Technical Bulletin – TBN-009

Product: LCV1 Toyota Landcruiser 78/79 series.

Subject: Small Backup Ring Added to EMMA Piston.

A photo of the new configuration is shown overleaf.

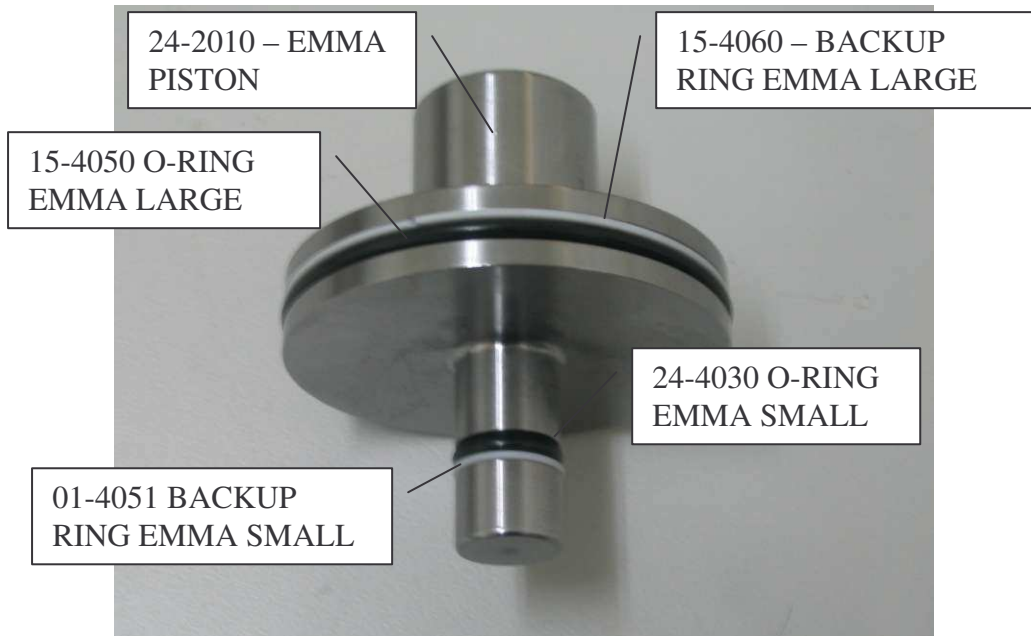
EMMA pistons produced after 01/05/05 have had the width of the groove for the small o-ring increased from 4.80mm to 5.30mm. This is to allow the inclusion of a Teflon backup ring alongside the small o-ring.

Customers with brakes made before 01/05/05 who order replacement EMMA pistons (Part Number 24-2010) should also order small backup rings (Part Number 01-4051) for installation with the new pistons. If a new type piston is installed without the small backup ring, the service life of the small o-ring may be reduced.
